IFB NO. 500640-FY26-31
WATER POLLUTION CONTROL FACILITY RAS/WAS PS IMPROVEMENTS - HYDROCYCLONES
ADDENDUM NO. 6

February 27, 2026

WATER POLLUTION
CONTROL FACILITY
RAS/WAS PS
IMPROVEMENTS
HYDROCYCLONES

E-102

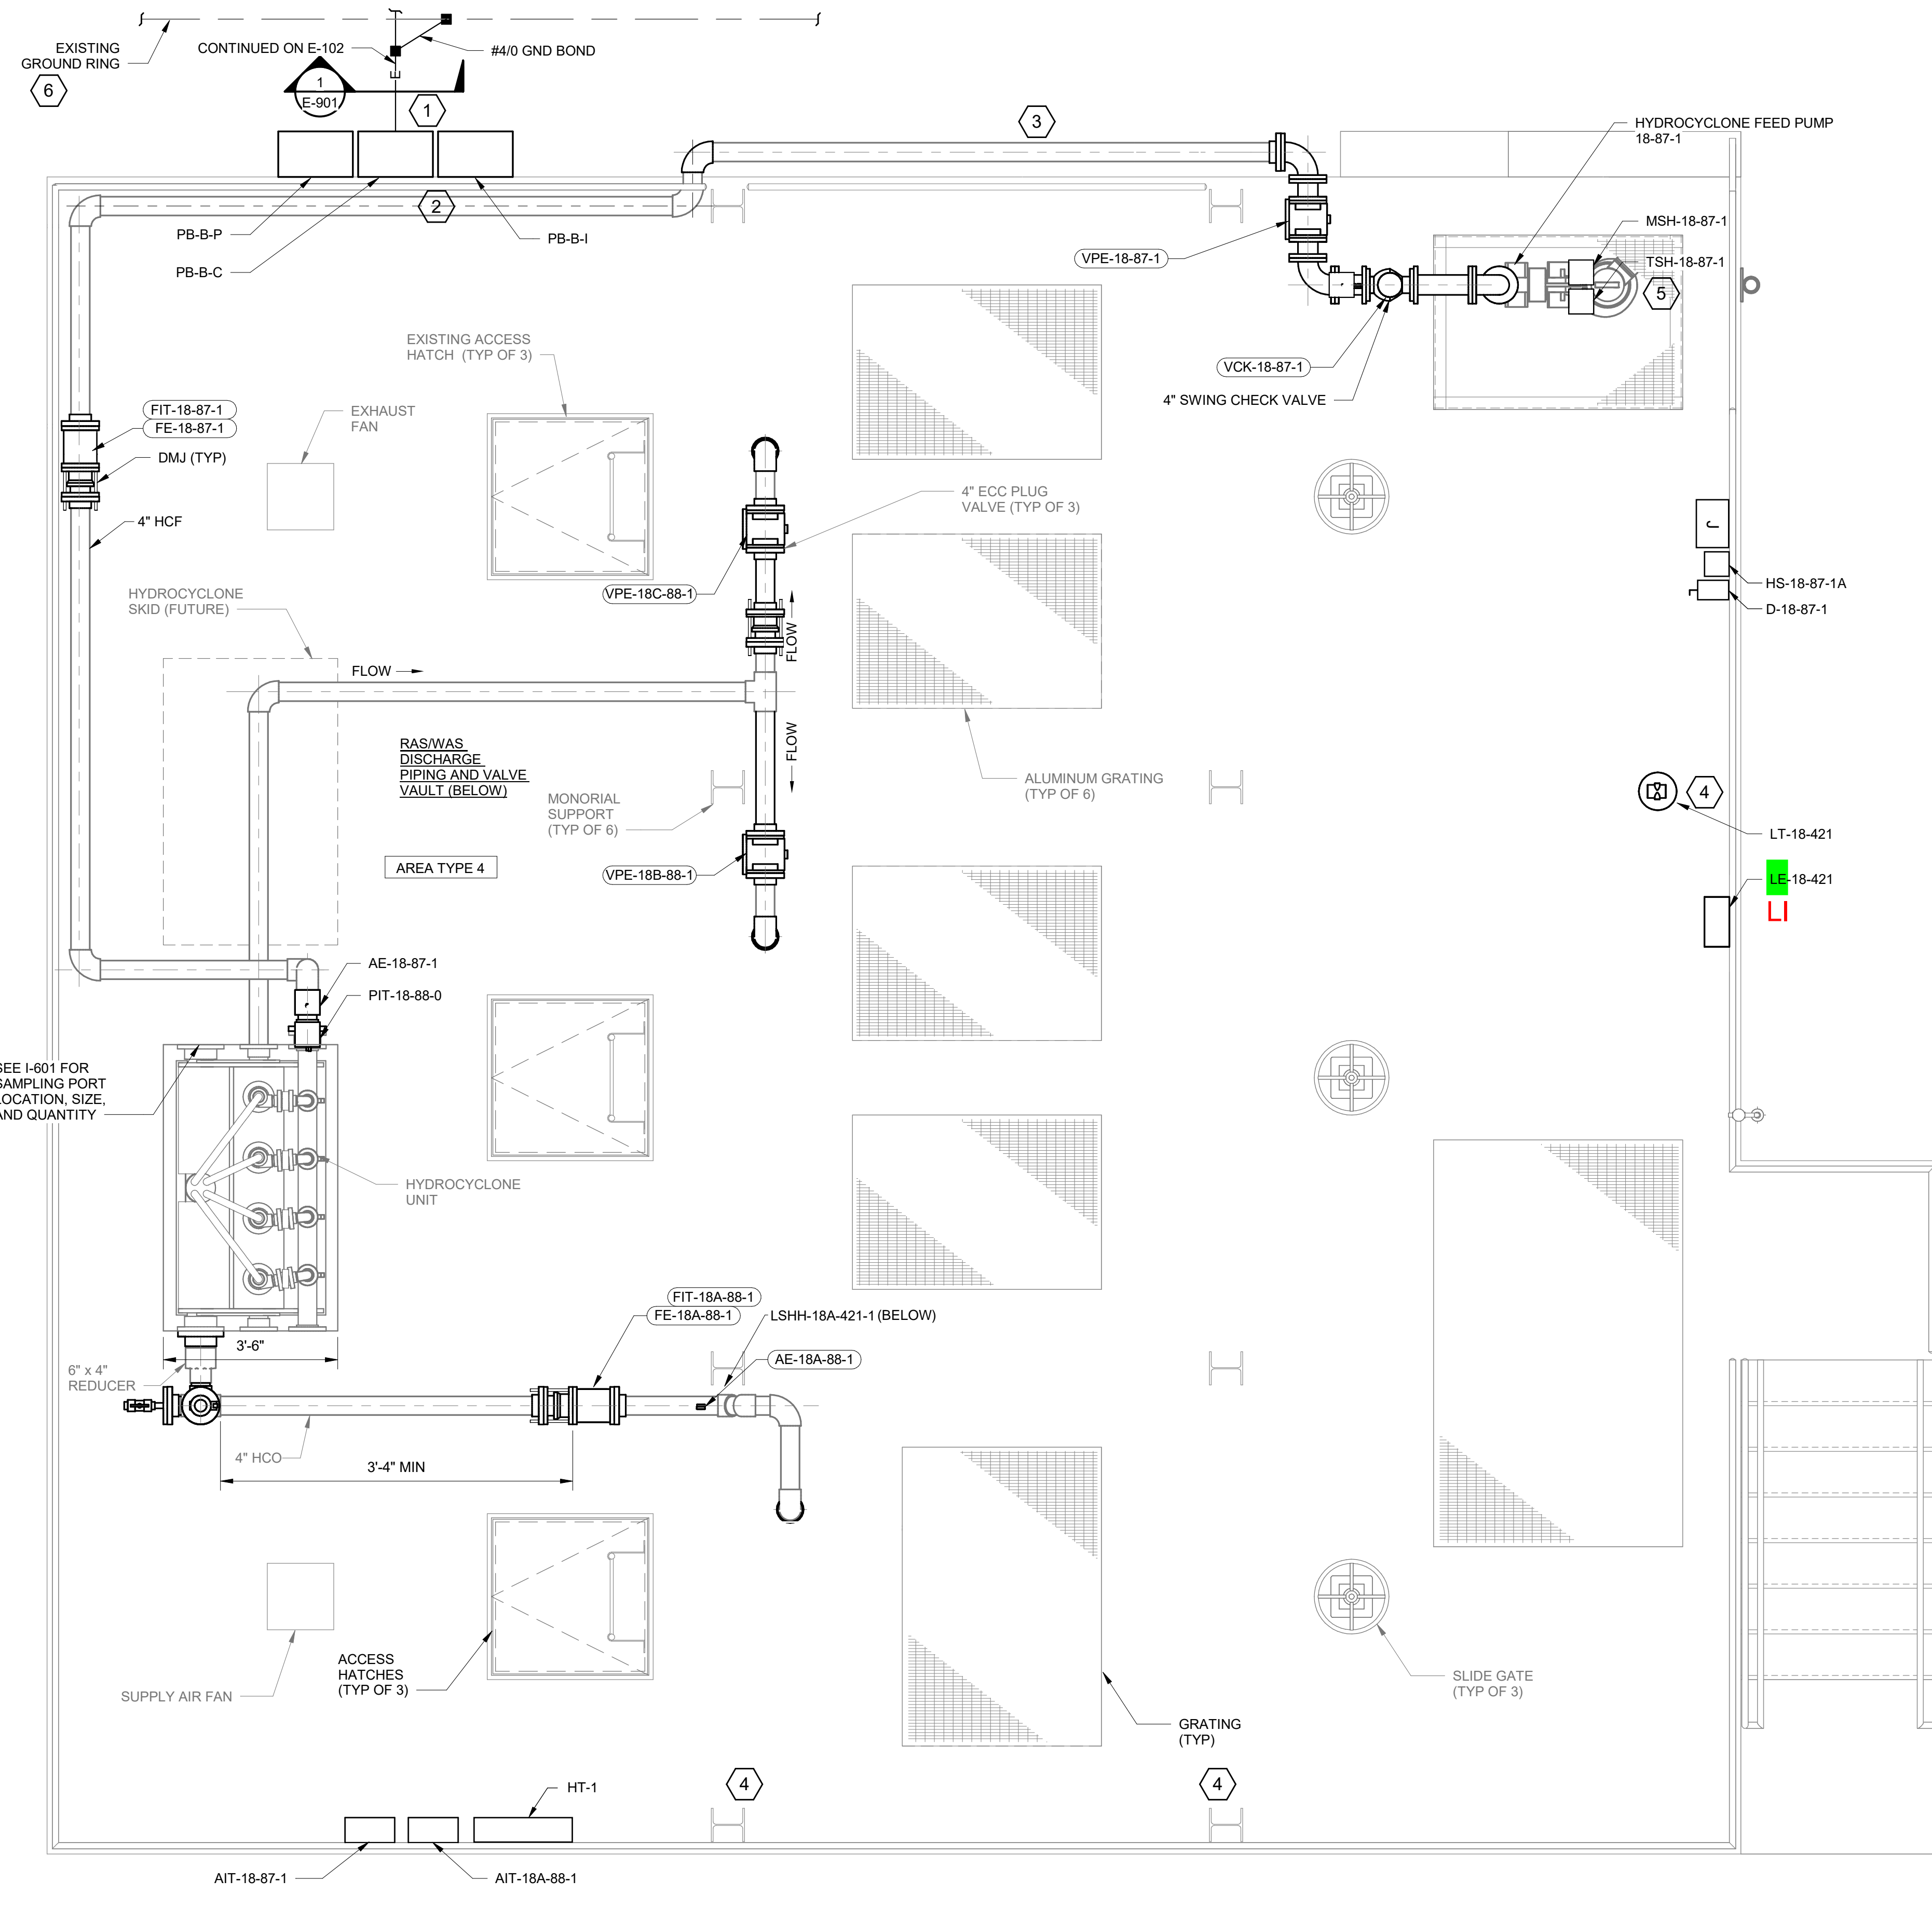
6. Drawing E-102 indicates panelboard LP-17-30A in the existing blower room, but an existing 480 volt is in that location. Please confirm the panelboard for these circuits.

RESPONSE: See attached markup of Electrical drawings. Panelboard LP-17-30B shall be used instead. Refer to Item No. 2 below.

E-601

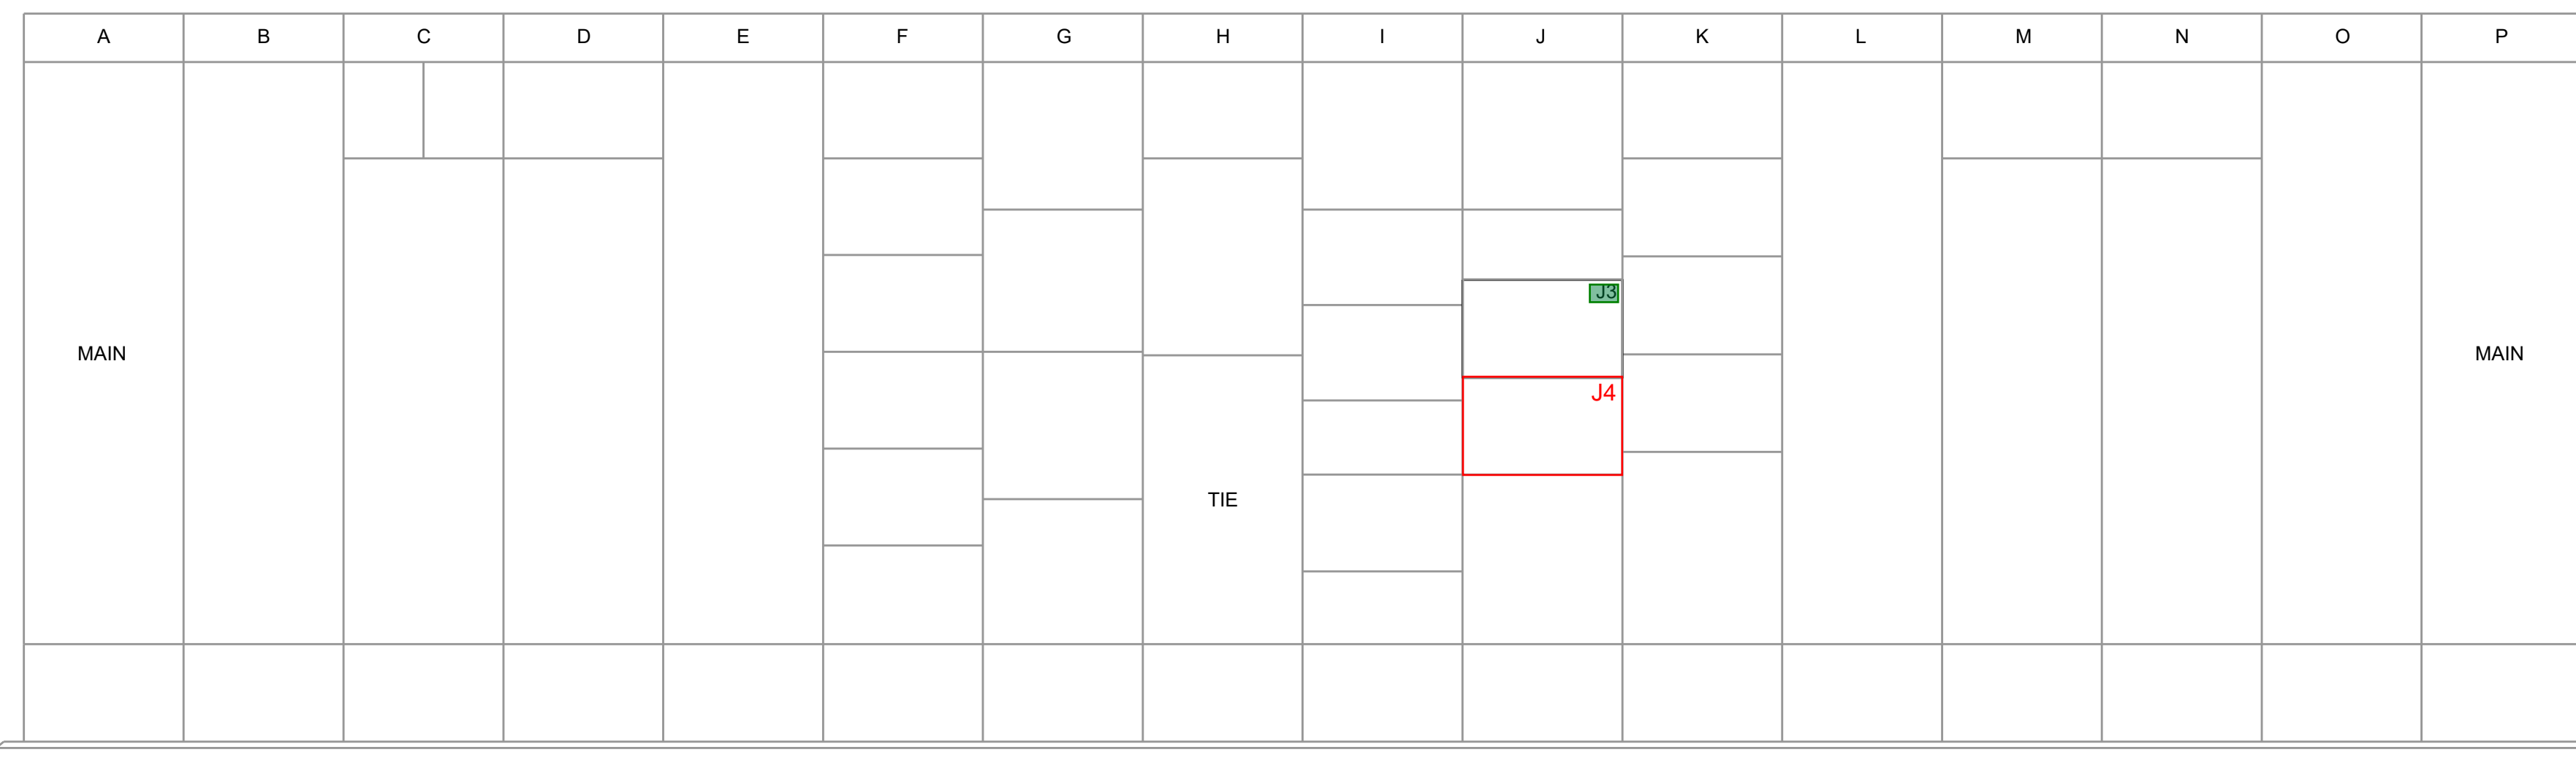
7. Drawing E-601 indicates utilizing MCC unit J3 in MCC-17-26B for the new Hydrocyclone Feed Pump VFD, but this MCC unit location is currently in use for other equipment. Please advise where to connect this circuit.

RESPONSE: See attached markup of drawing E-601. Bucket J4 shall be used. Refer to Item No. 2 below.

E-901

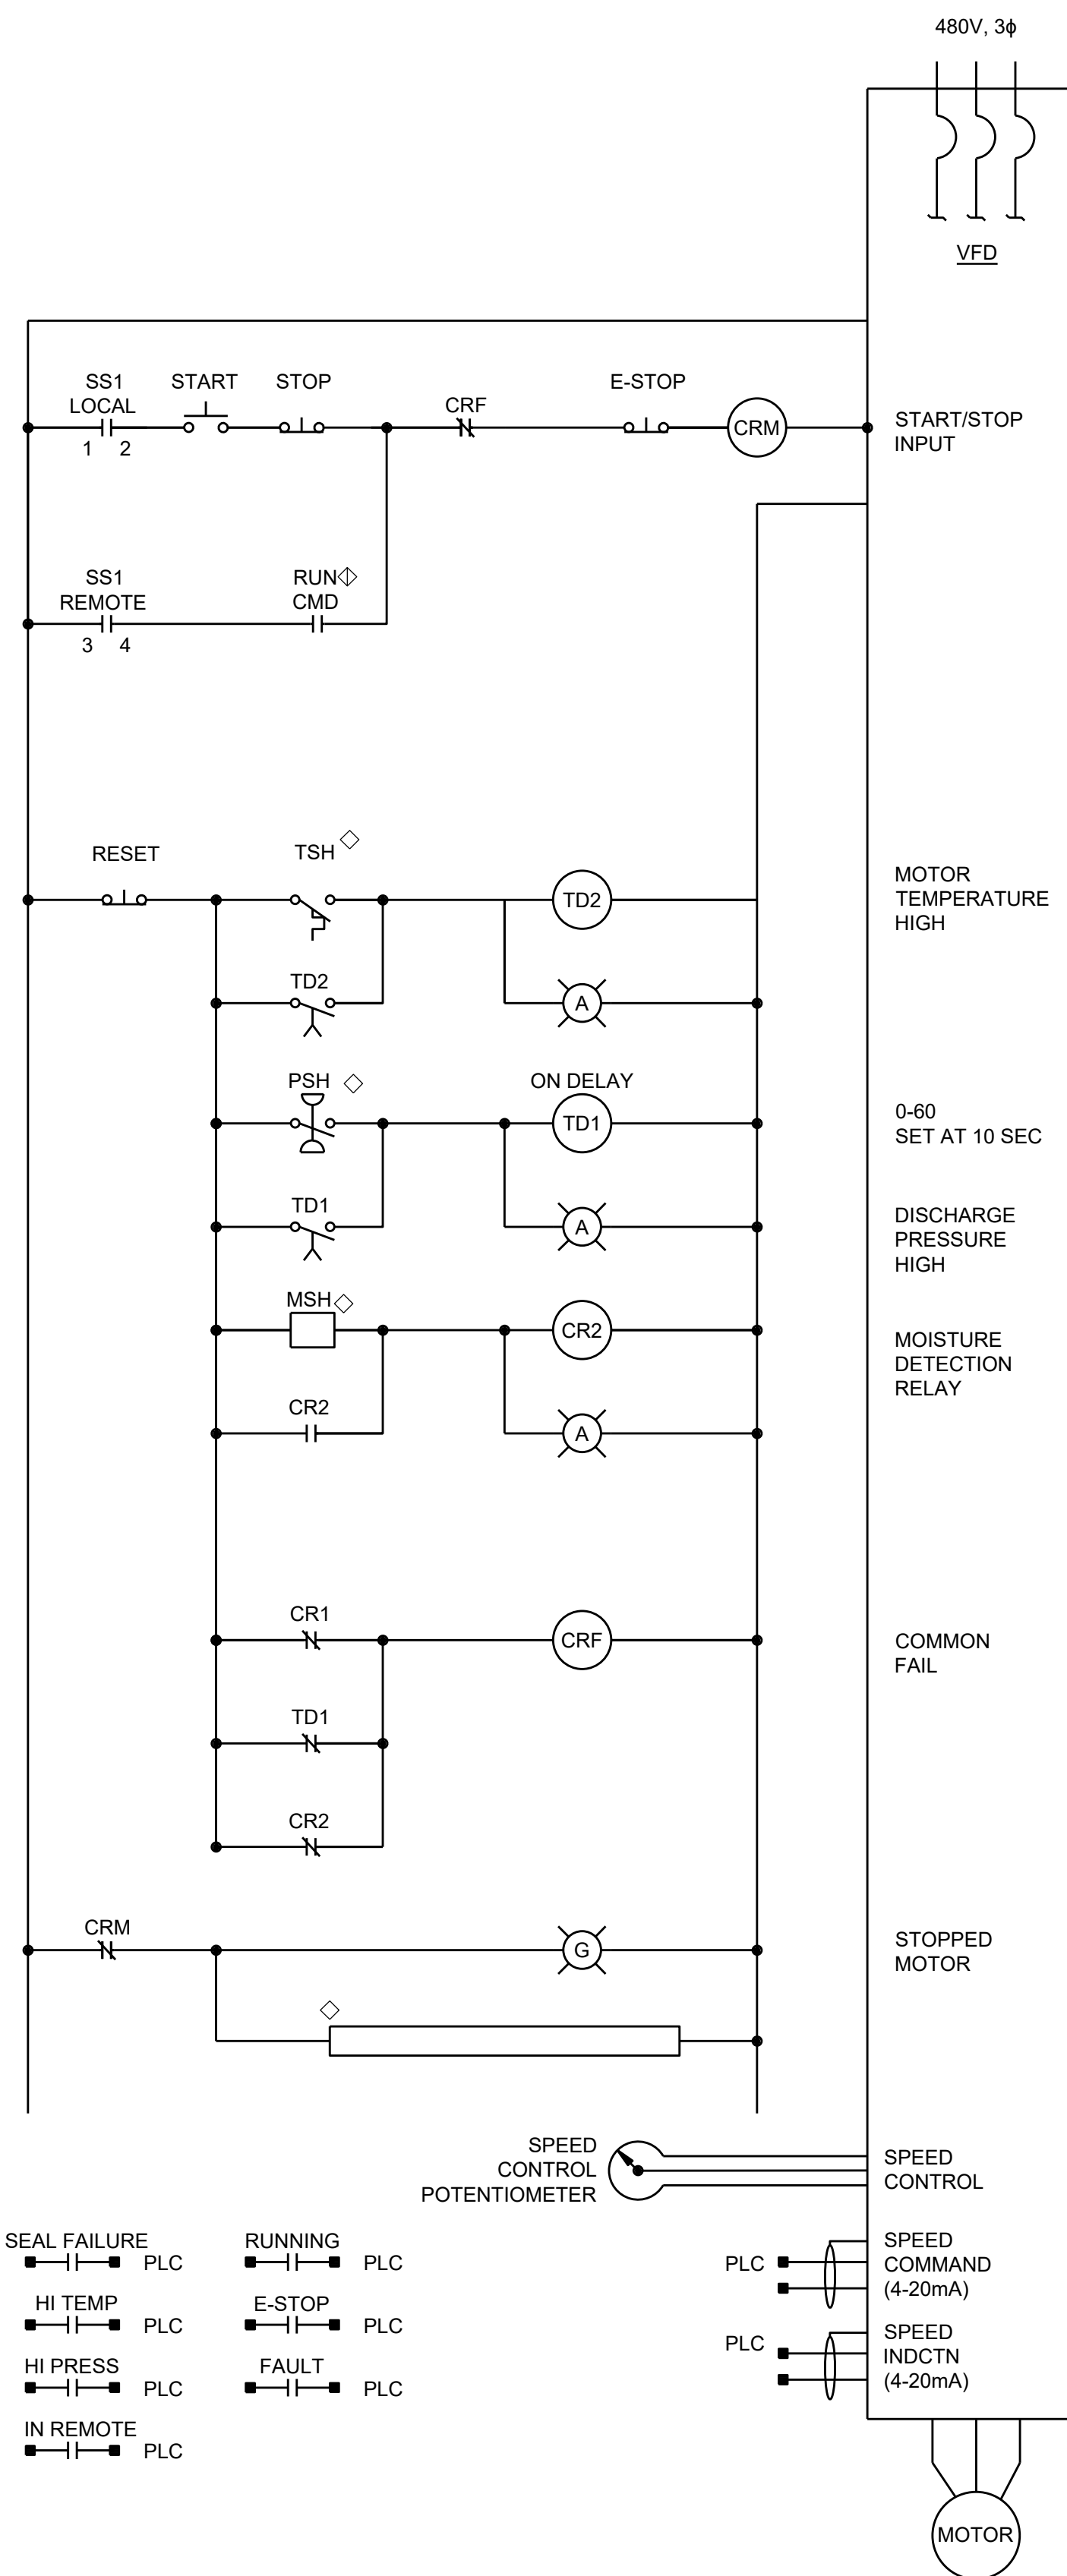
8. Drawing E-901 indicates specific conduits in the duct bank but does not clearly indicate which pull boxes they go to, especially the spare conduits. Please clarify which pull boxes connect to which conduits.

9. Drawing E-901 indicates new circuits being installed in panelboard LP-17-30A, but the indicated circuits appear to be in use already in the panelboard. Please clarify new circuit connections.

RESPONSE: Terminate the 3" spare conduit within the power pull boxes (PB-A-P and PB-B-P). Terminate one 2" spare conduit at the controls pull boxes (PB-A-C and PB-B-C). Terminate one 2" spare conduit at the instruments pull boxes (PB-A-I and PB-B-I).

RESPONSE: As clarified in question 6 above, these new circuits shall be energized from panelboard LP-17-30B.
